Structural Power Cube

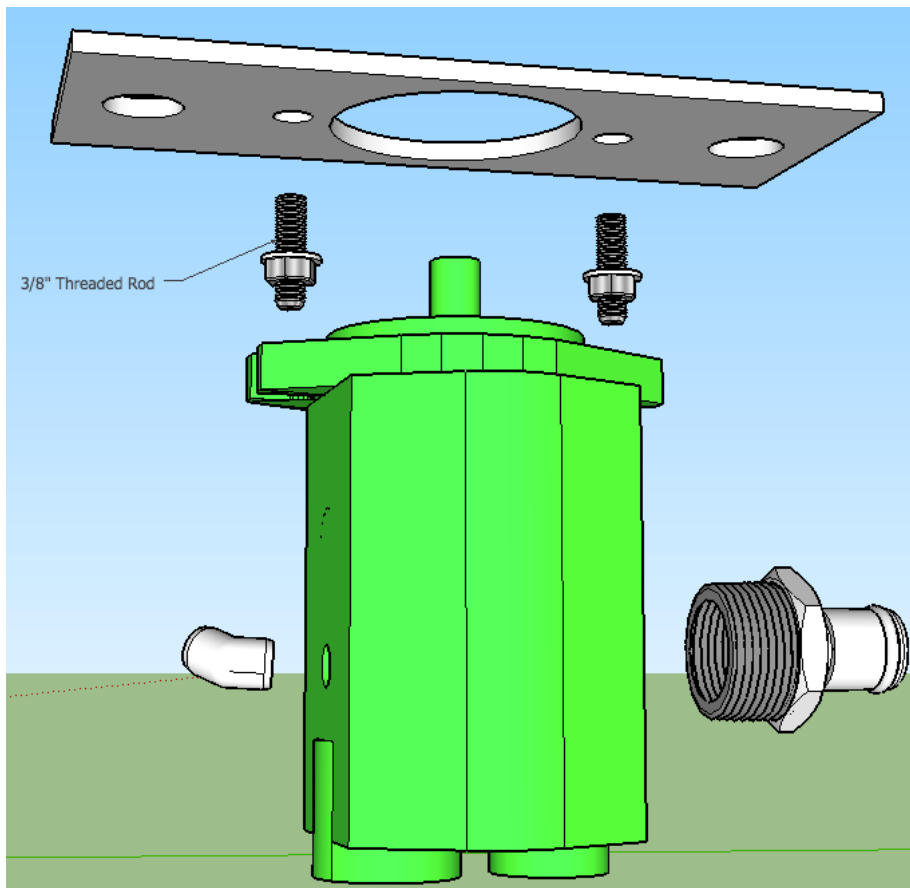
I have a question about the engine/pump mount piece. I was wondering if you had a suggestion as to how to go about cutting it for clearance fr the pump/engine. I was thinking I would bolt on the plates, mark the holes, take off the plates and torch it. What do you think?

I made an omission - the 4" x 4" tube supporting the engine and pump should have the 1" hole on top and bottom enlarged to 2" for clearance for the shaft coupling - like so:

If I were cutting it, I'd just mark the circles with something like a socket about 1 1/2" to 1 3/4" outer diameter (allow for standoff of the marker), then cut the circles with the torch. If the engine plate is already cut to 2 1/4" diameter. The 1" holes securing the pump and engine plates should line up with holes already in the tube and will be secured with short bolts about 1 1/2" long.

Also: note that on the inside of the 4" x 4" tubing is a seam where it was welded lengthwise to form the tube. This seam should be oriented on the side facing the hydraulic reservoir. The seam is on the inside of the tube, and we will have them on the inside of three sides of the tube.

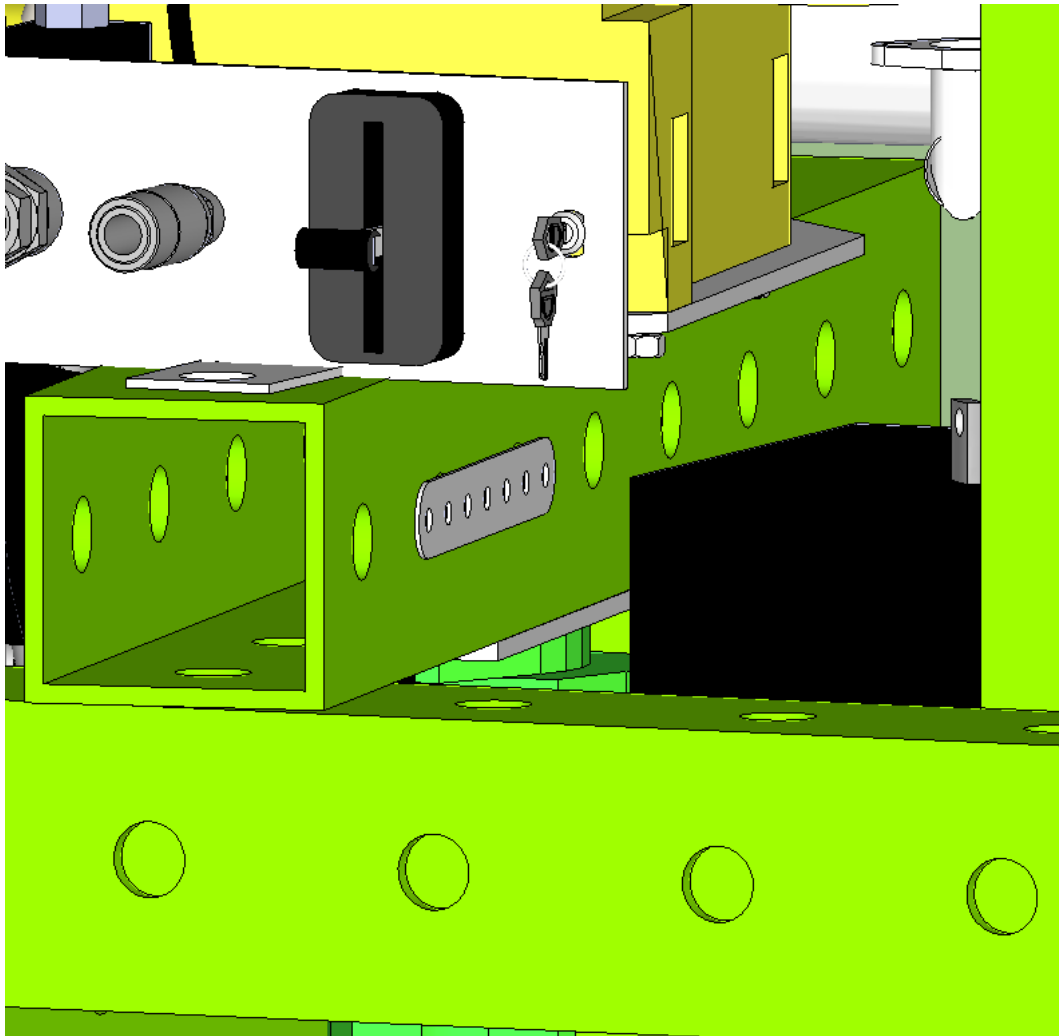
any thoughts on where the solenoid should mount?

I had in mind using a support bracket as on the other power cube I delivered - bent so two of the holes would align with the 4" holes in the structural steel.

Here is the area I had in mind - beside the battery:

I have only added the metal strip to show where I was thinking of placing it. The strip must be bent as before and bolted to the 4" tube, then the solenoid bolted to the metal strip. I'll try to draw it in more detail, but Sketchup doesn't have an image of a solenoid. Also, the tube is not aligned to the green axis and bending the metal strip is easier to do in person than in Sketchup.

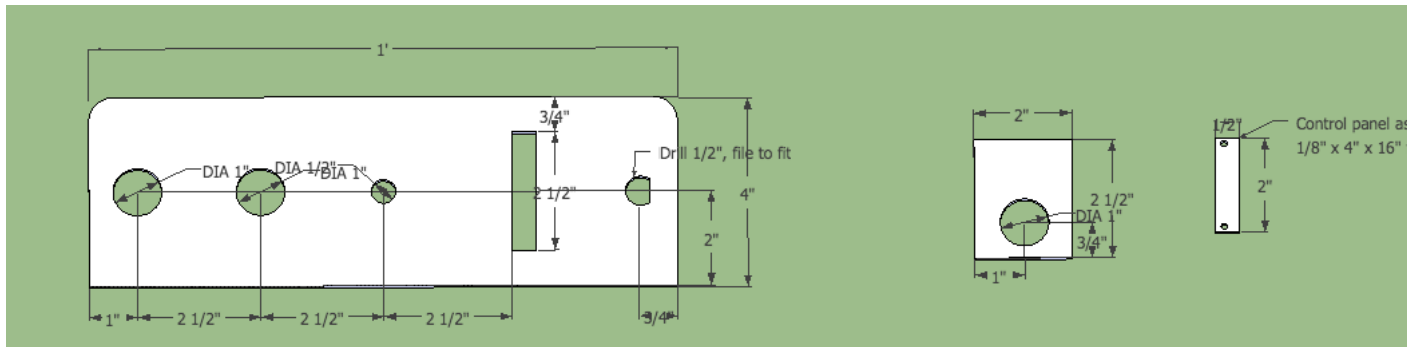
For throttle lever connection is there supposed to be some flat welded at 90 to the back of the control panel for the lever to bolt to like the last ones we built?

Yes - I had drawn the metal piece, grouped with the control panel assembly, but haven't show it attached to the control panel yet:

Note that the dimensions for hole sizes and positions aren't shown - I will add them when I get to the shop and measure the holes in the throttle control. I believe they are 3/16" holes and are side welded to the control panel. Holes are roughly 1 1/2" - 1 3/4" apart. YMMV.

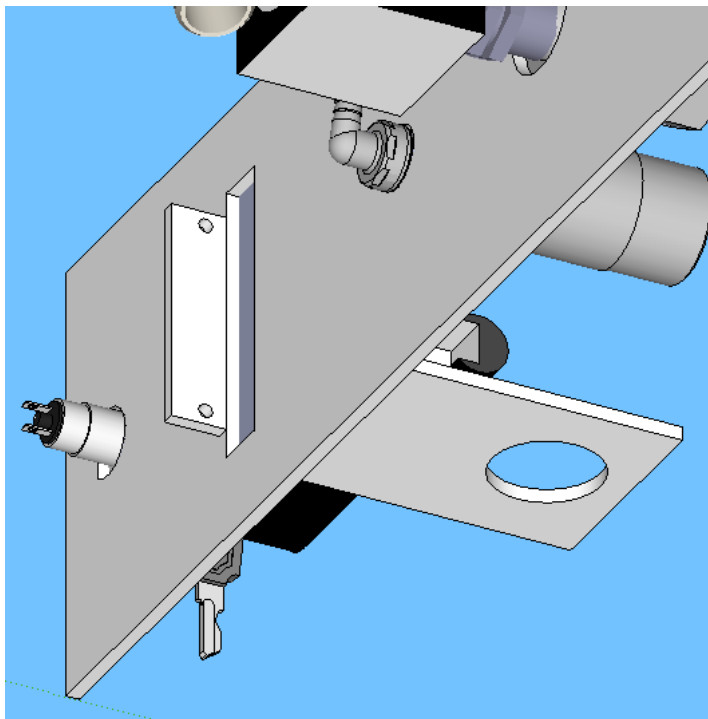
I've added it to the drawing - even without exact dimensions. On the Power Cube I delivered, I think it was welded on the other side of the slot for the throttle control, but I wanted it on the opposite side for the future. Can you verify this is correct?:

the power cubes we built here have it on the opposite side from the drawing
I torched the control panel 5 mins ago. shot a video. will upload soon
[Quoted text hidden]

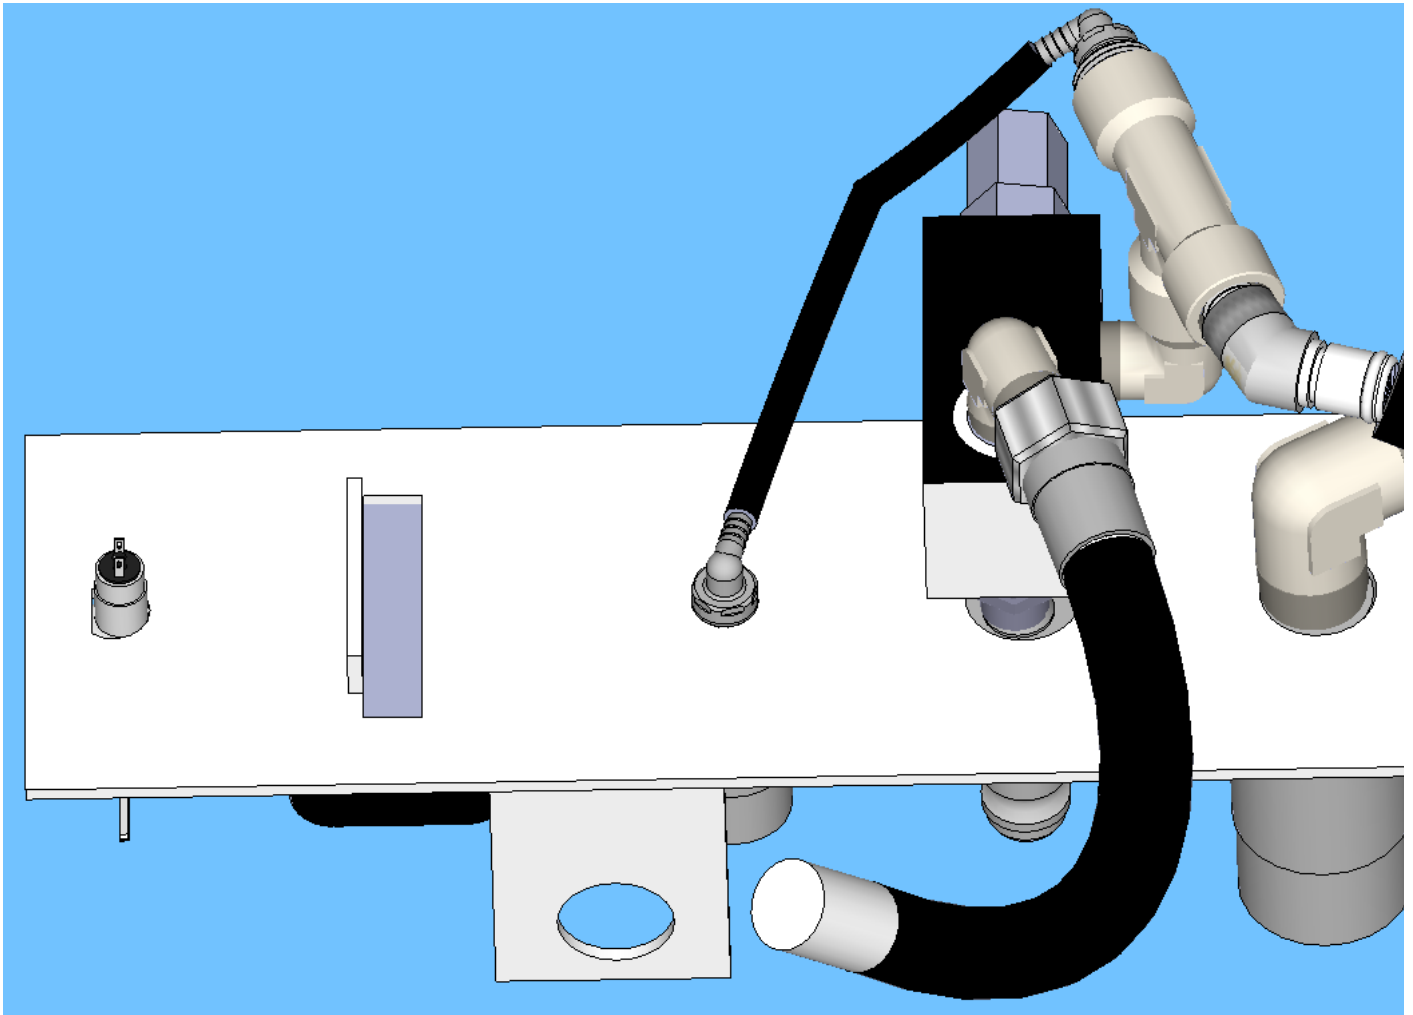
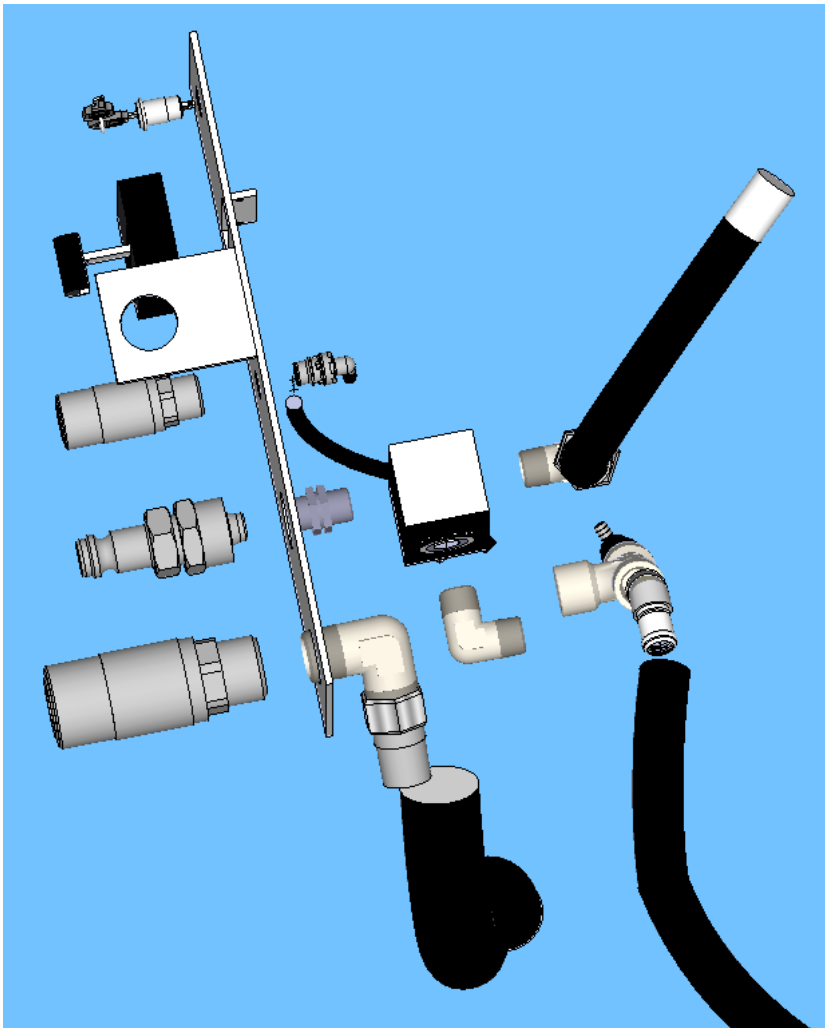
Your picture shows three elbows with JIC fittings, though there should only be two - one 3/4" and one 1/2".

The control panel module parts should look like this:

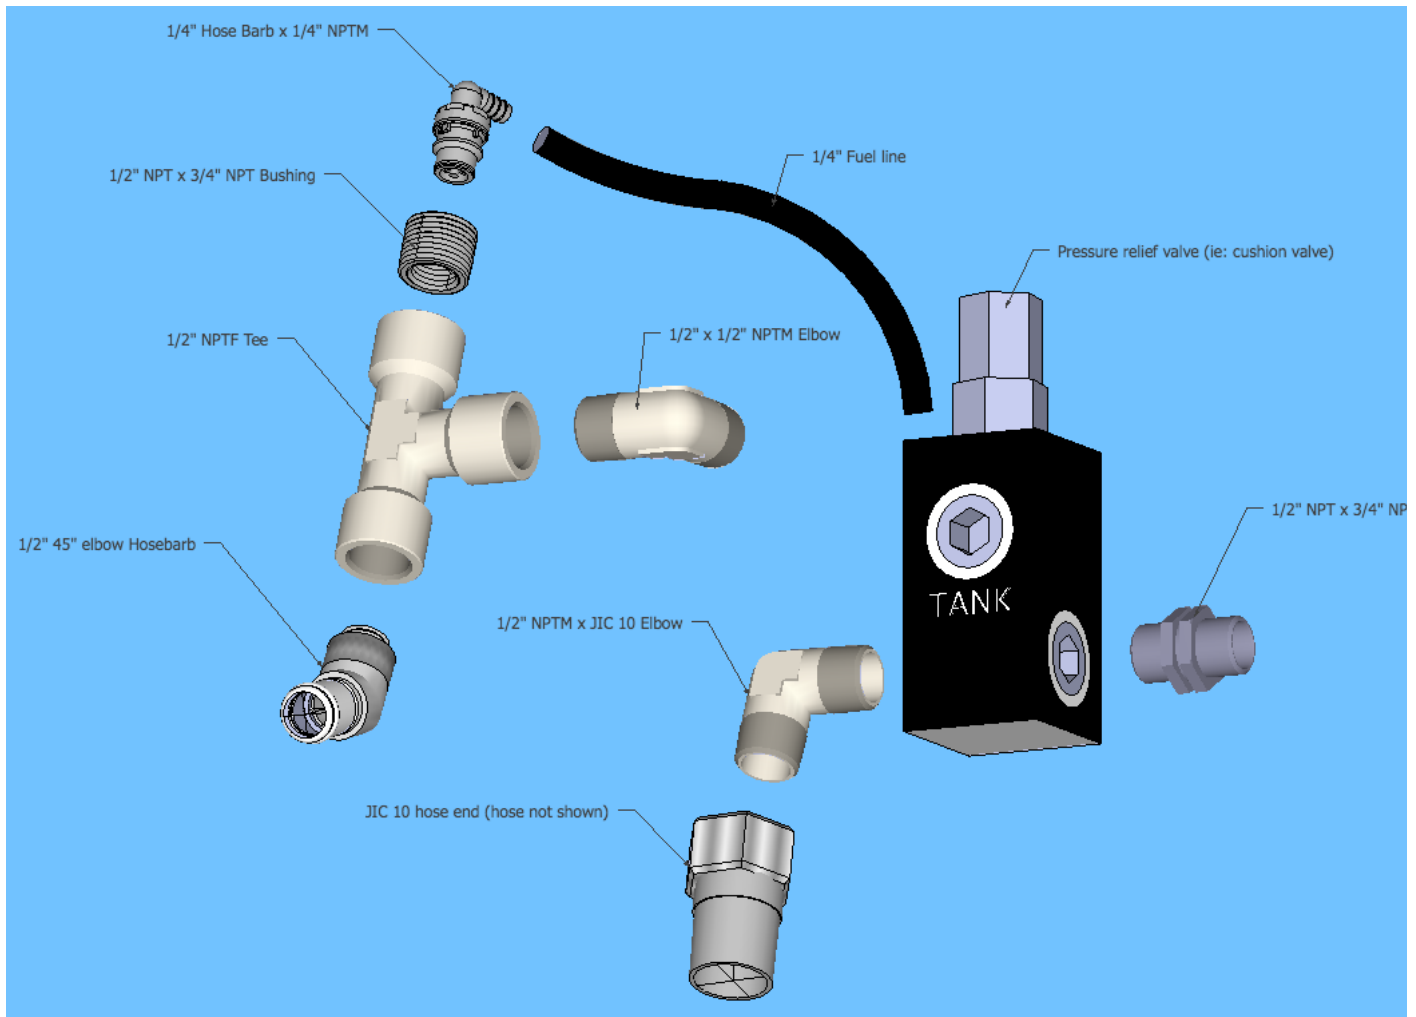
My main points of confusion are:
What connects to the cushion valve? Right now I have an elbow to a T for the return and a nipple for the output quick connect. Nothing else appears to fit for the input.
How are hoses connected to the fittings? The hoses I have all terminate male.
The pictures aren't quite doing it for me.

Here is a diagram with all the parts for the Pressure Relief (ie: cushion) valve:

I think I included all parts, except maybe for the 1/2" NPT 3/4" NPT bushing.

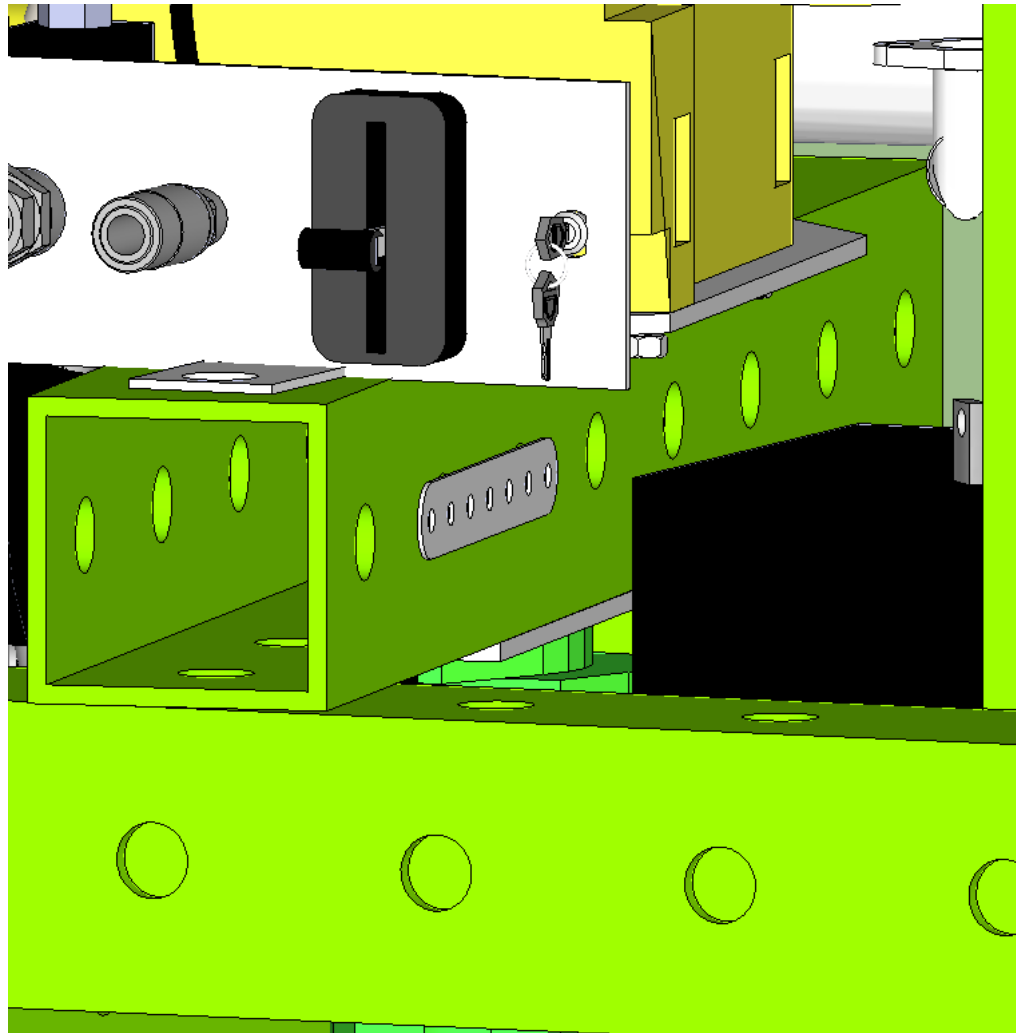
Hi Tom,
I'm trying to assemble the control panel hydraulics.
I don't think what you send is fitting together properly - or i'm doing it wrong.
I attached a picture of my present status.

None of the elbows fit into the pressure bypass valve except for the one that is already in.
Also, how do I put the case drain barb into the Tee? Do I need a 3/4M to 1/4F reducer?
How do the hoses attach to the fittings?

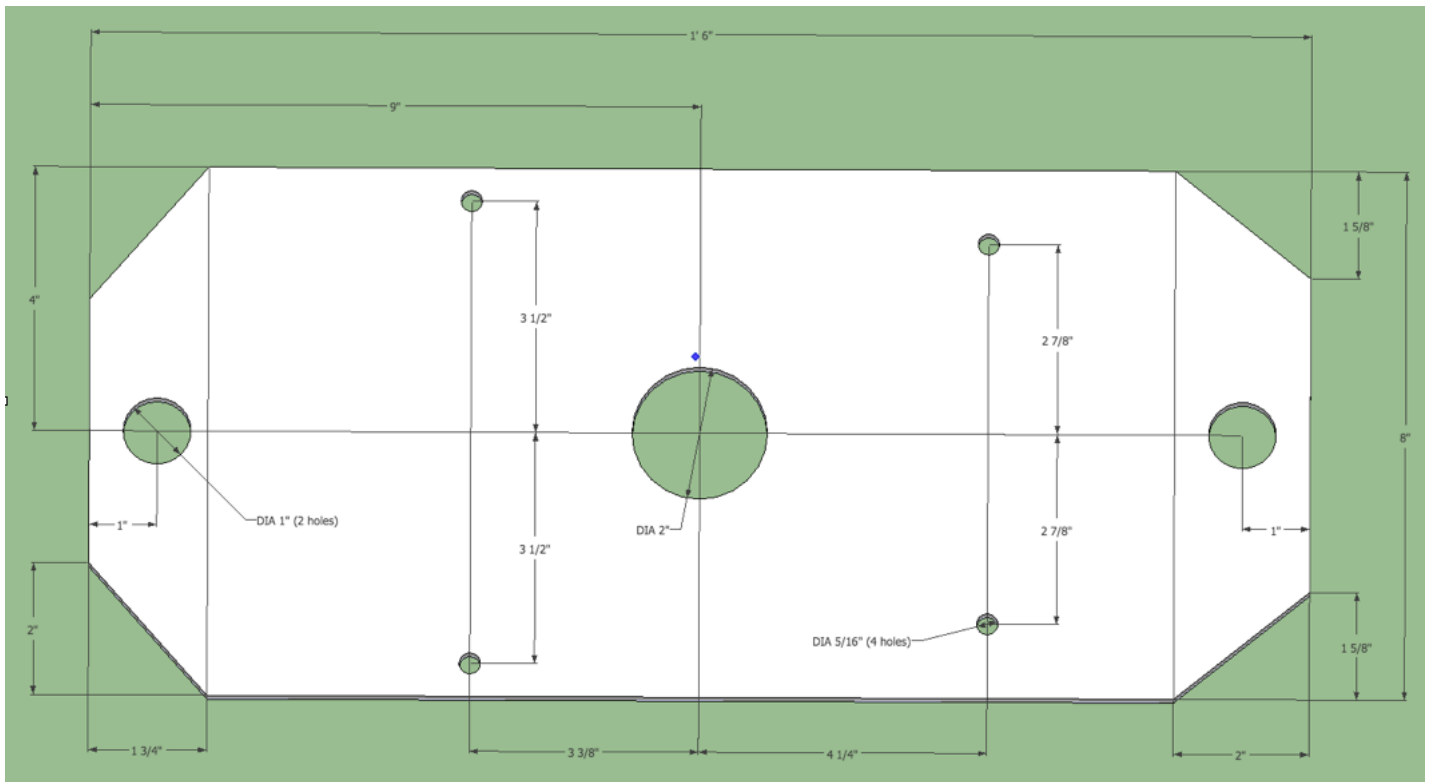
It's not the hole in the tube that is the problem - it's the engine mount plate. I'm making new ones. The bolt spacing on them is not suitable for the gridbeam. Also, it was impossible to put a 3/4 bolt through the bolt hole closer to the engine shaft.

Here is the latest on the engine plate:

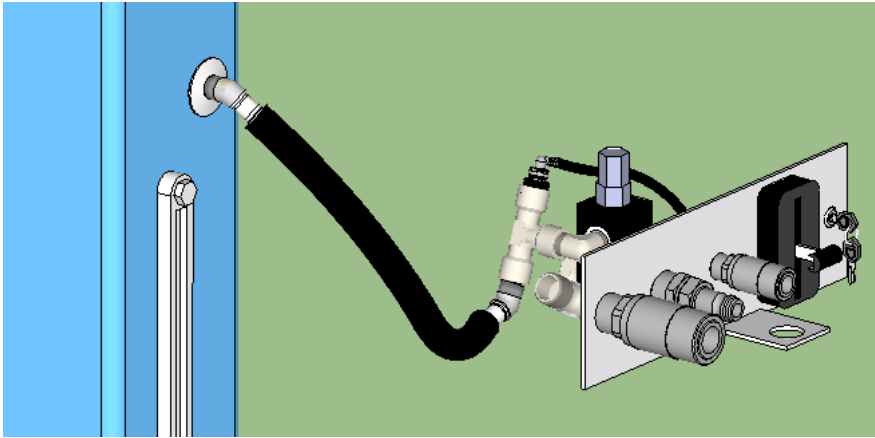
No problem.
This assembly is taking longer than expected - as expected.
Most everything else seems good. What is the red tube in the hydraulic reservoir bag for?
-Aidan
[Quoted text hidden]

Oh . . . that's the 1/2" rubber hose that will connect between the hosebarb on the control panel to the Hydraulic reservoir:

I colored it black, but the one they had in the store was red.
There should be medium size hose clamps for this as well.
There should be enough of it for the two power cubes.

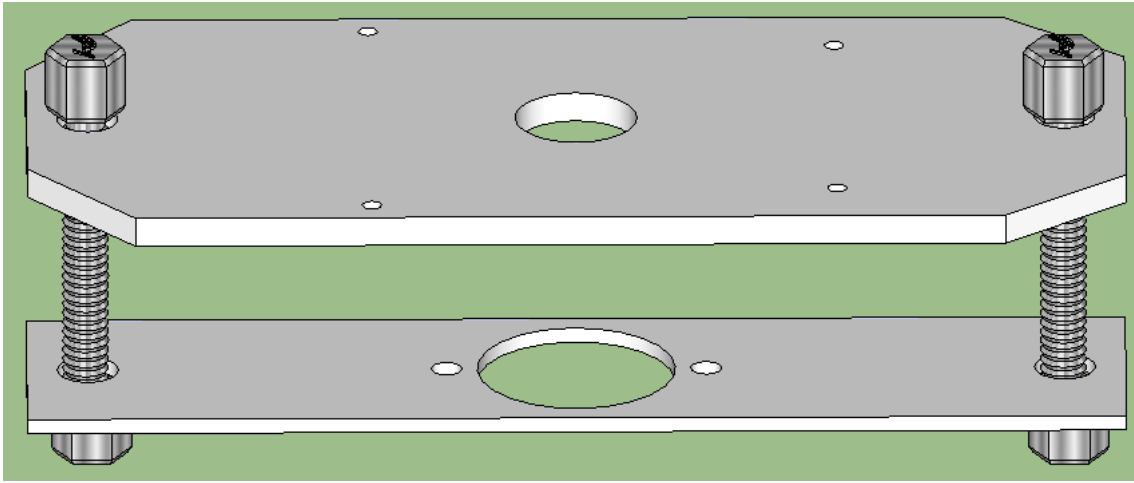
yes except the pump plate as the same profile as the engine plate. I was thinking about cutting it down but my accomplice - Mathias- thinks it's better to leave it 8" wide. What do you think? I'm thinking it would be difficult to access the set screw on the coupler if you want to switch out pumps to a different pump type.

Oh . . . you mean use 1/4" x 8" steel for the pump plate? I'd think 1/4" x 6" steel would be plenty strong - But that's just me.

The weak point is the thin parts near the large hole. When it was shorter, the 1/4" x 4" steel would have been strong enough - but we just extended it by 8", so it's more of an issue.
